# Amesbury School Building Committee November 19, 2020

# Amesbury Elementary School

# Project Updates

# Waiver Request 1 | Zoning Bylaw Section VIII.G.16

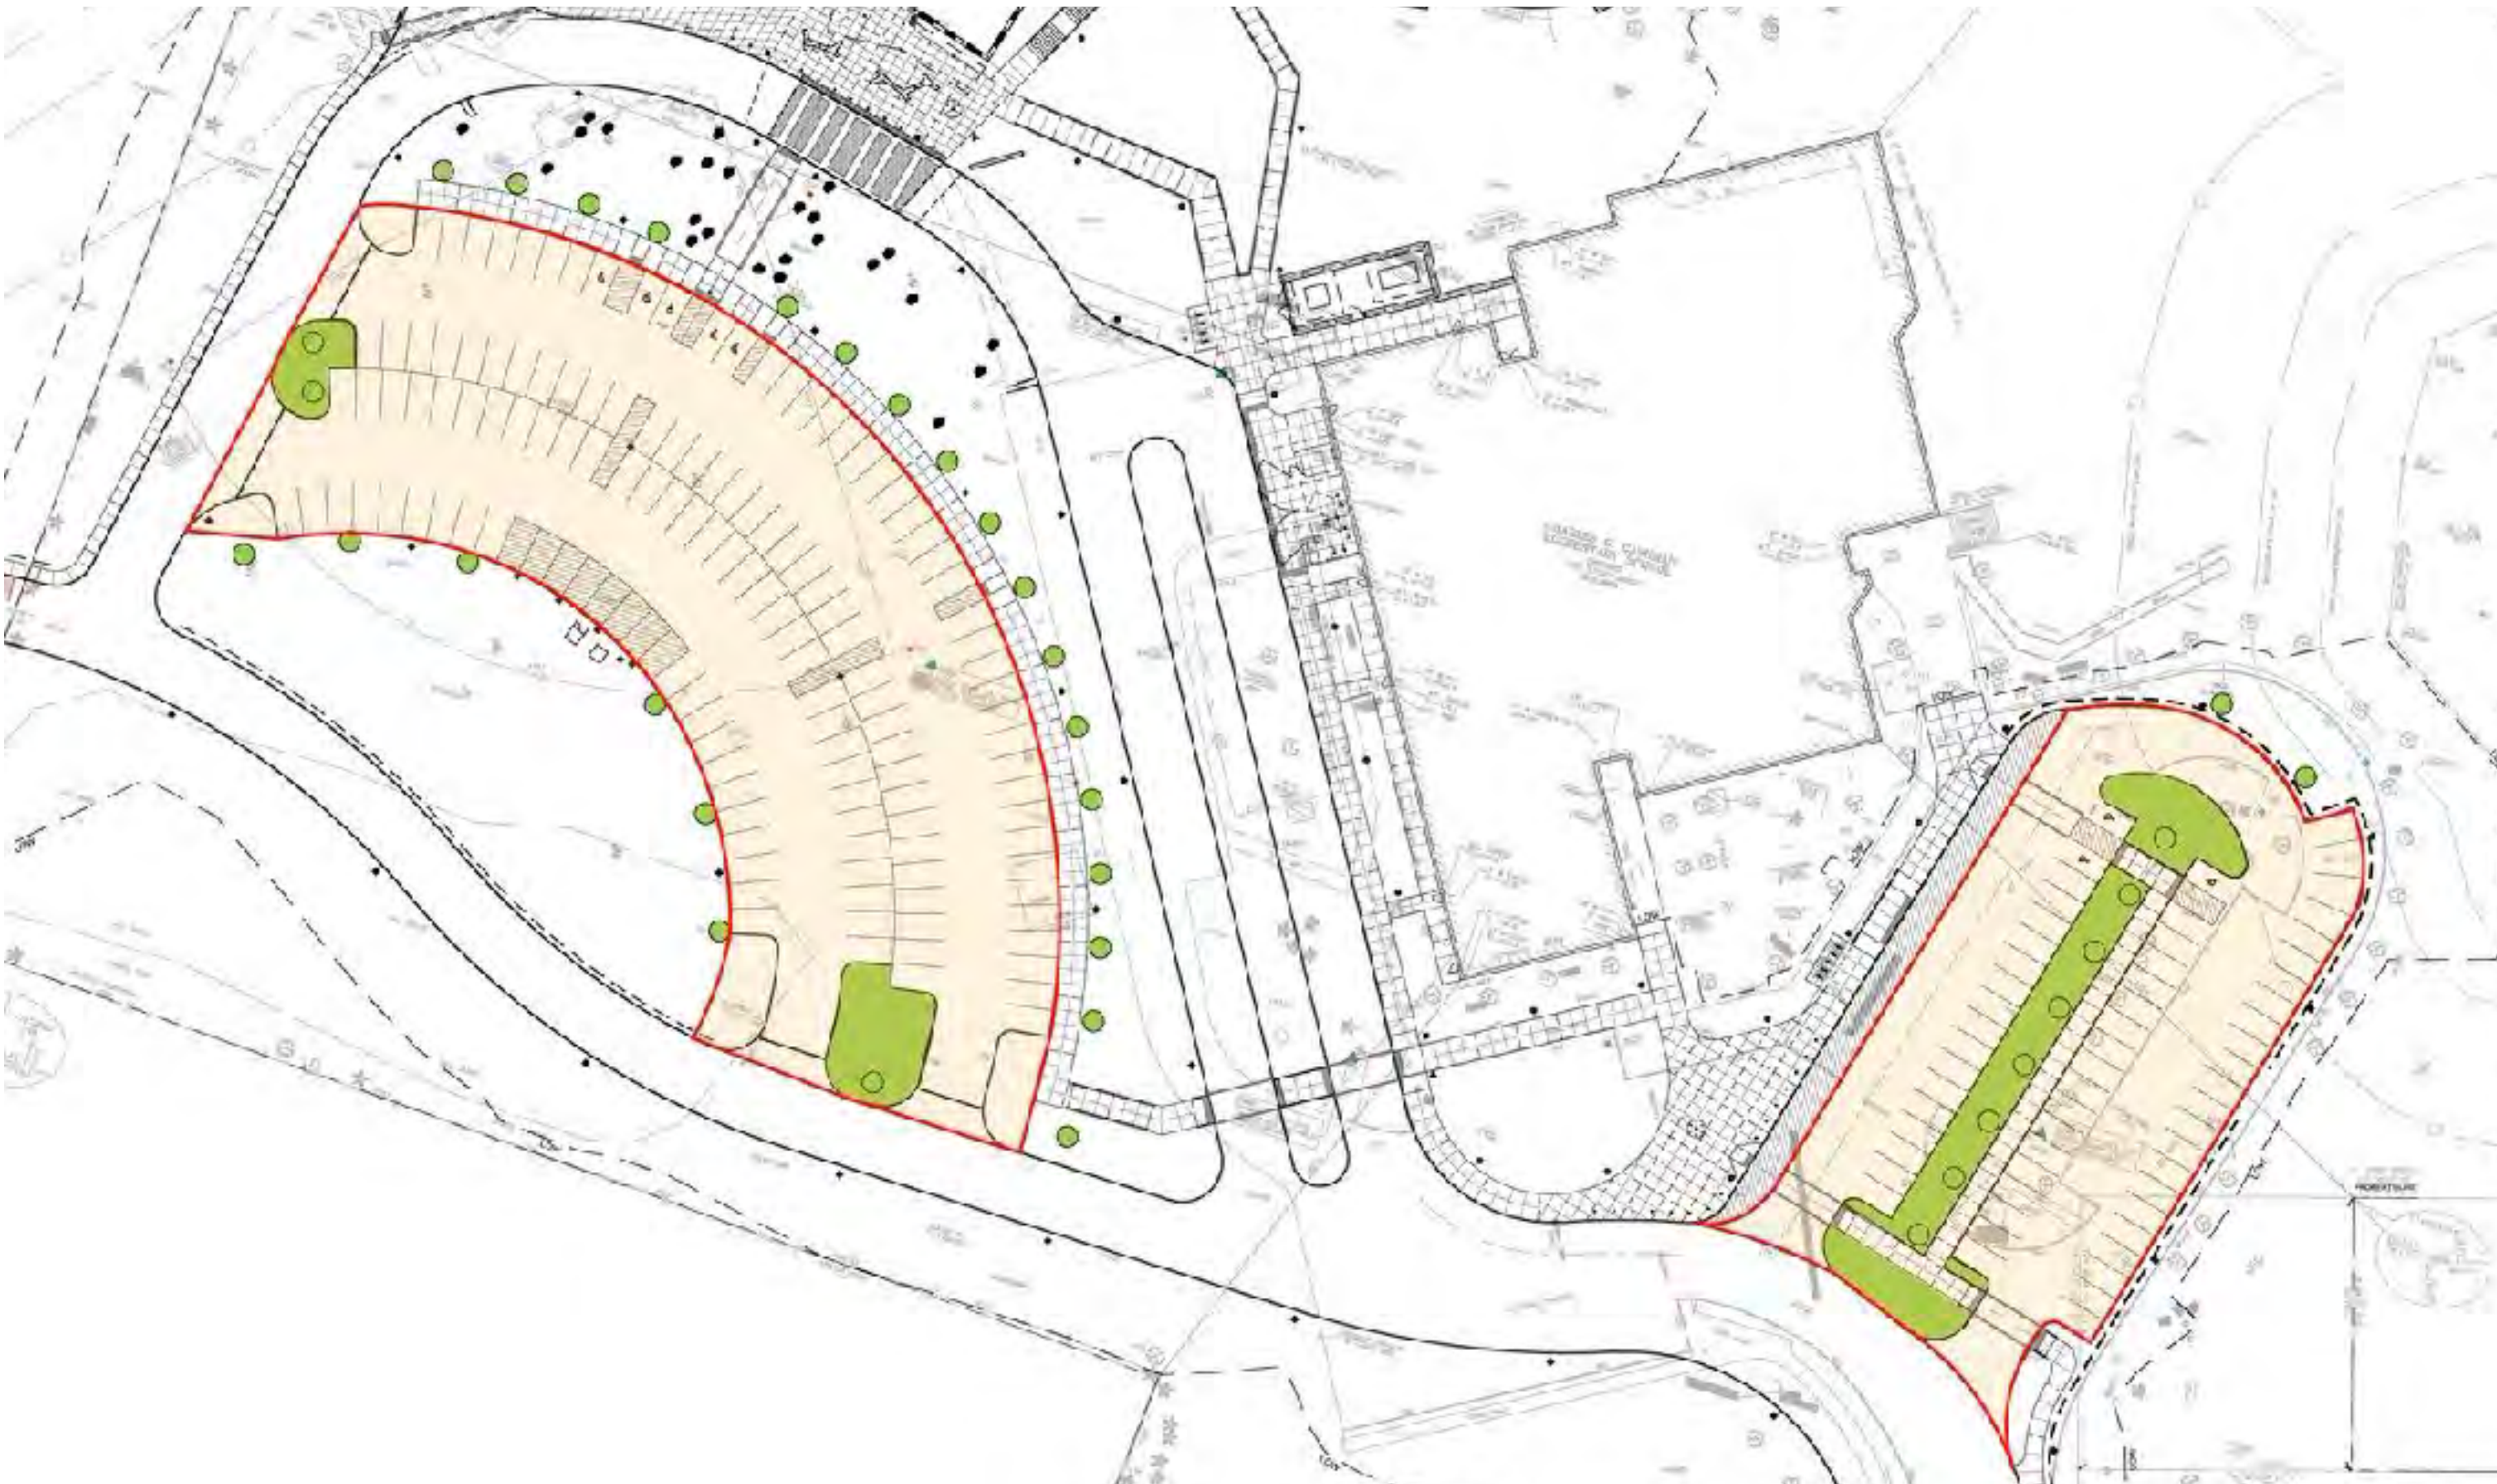
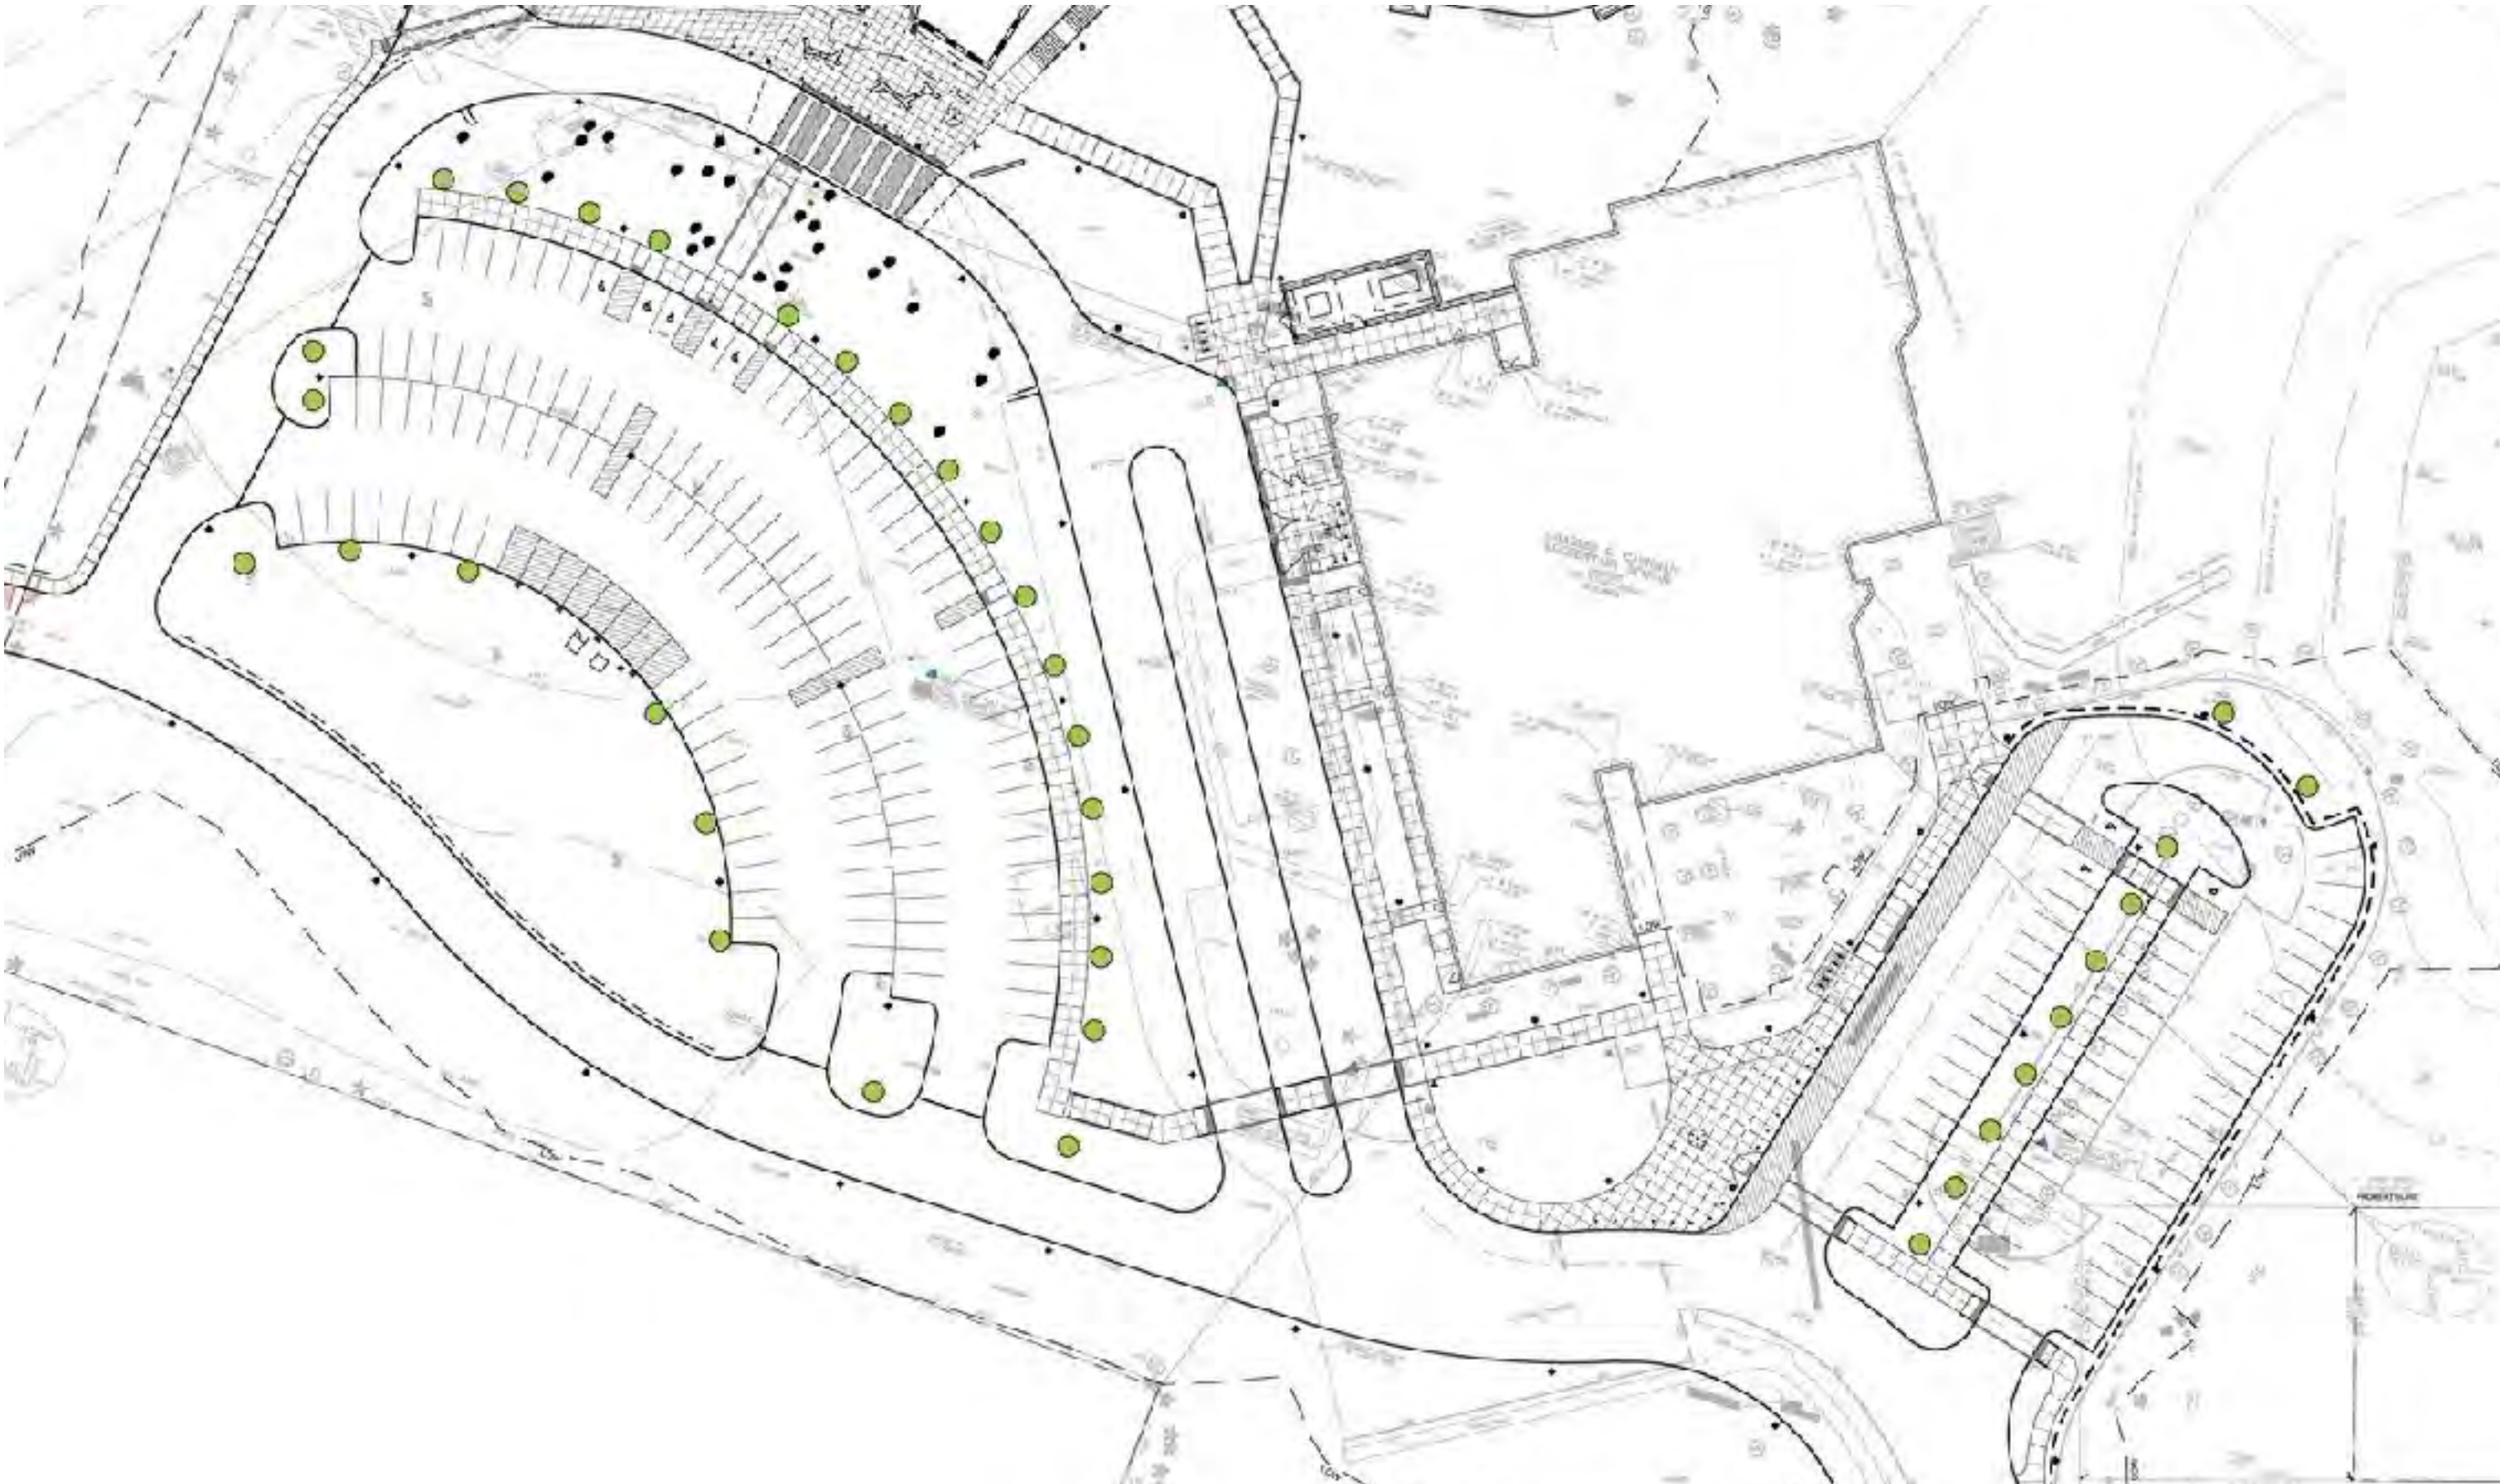
Main Parking Lot 49,608 SF	Required	Proposed
% of landscaped Area	5%	4.6%
Area (SF)	2,480	2,260
Islands every 20 Spaces	Yes	No

Cashman Parking Lot 30,478 SF	Required	Proposed
% of landscaped Area	5%	15.9%
Area (SF)	1,524	4,847
Islands every 20 Spaces	Yes	No

Main Parking Lot 49,608 SF	Required	Proposed
% of landscaped Area	5%	6.6%
Area (SF)	2,480	3,252
Islands every 20 Spaces	Yes	Yes

Cashman Parking Lot 30,478 SF	Required	Proposed
% of landscaped Area	5%	16.4%
Area (SF)	1,524	5,009
Islands every 20 Spaces	Yes	Yes
